CS1 Lovell: a present floor field does not match the landing top

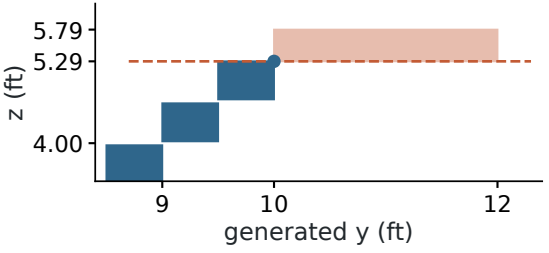
floor_z = 5.29 ft (present)
Landing top = 5.79 ft
Stair endpoint z = 5.29 ft

Q09 = UNKNOWN, not a missing field.
